Addendum 6 – Regulation No. 7

Revision 6 - Amendment 1

Supplement 21 to the 02 series of amendments – Date of entry into force: 15 July 2013

Uniform provisions concerning the approval of front and rear position lamps, stop-lamps and end-outline marker lamps for motor vehicles (except motor cycles) and their trailers

1. Front position lamp

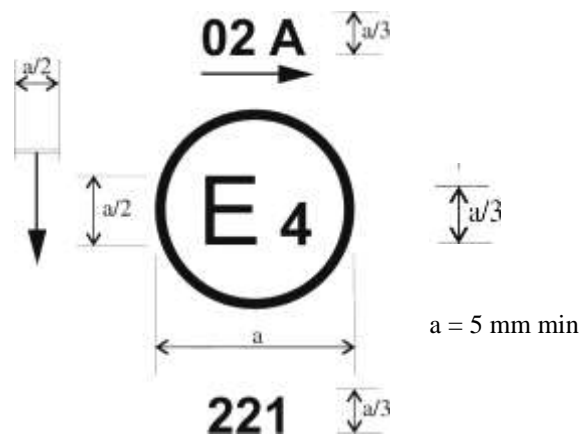
Paragraph 1., amend to read:

The device bearing the approval mark shown above is a front position lamp approved in the Netherlands (E4), under approval number 221 pursuant to Regulation No. 7.

The number mentioned close to the symbol "A" indicates that approval was granted in accordance with the requirements of Regulation No. 7 as amended by the 02 series of amendments. The horizontal arrow indicates the side on which the required photometric specifications are met up to an angle of 80° H. The vertical arrow starting from a horizontal segment and directed downwards indicates a permissible mounting height of equal to or less than 750 mm from the ground for this device."
